FY 2011 Capital Budget TPS Report 54489v1

Joel's Place - ADA Compliance Remodel

ACCESSIBILITY ASSESSMENT CONDUCTED BY ACCESS ALASKA / FAIRBANKS

JOEL'S PLACE 1890 MARIKA DRIVE FAIRBANKS, ALASKA 99709 JANUARY 11, 2010

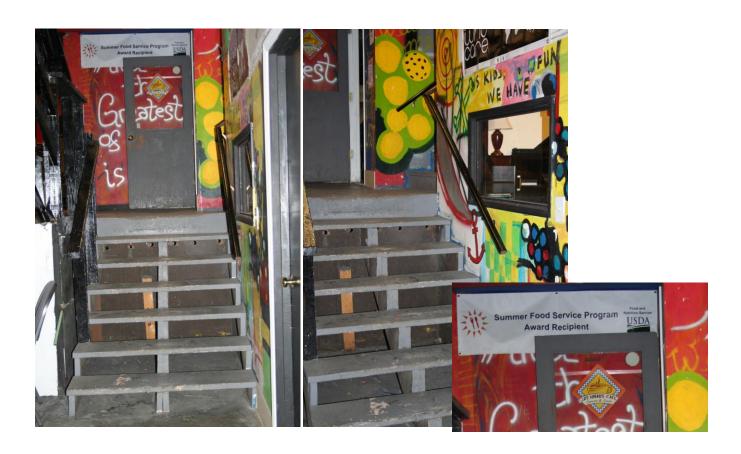
Priority One: Accessible approach and entrance This is the main entrance to Joel's Place.

Priority Two: Accessibility to Programs and Services Stair lift to from ground level to the café where we serve youth meals!
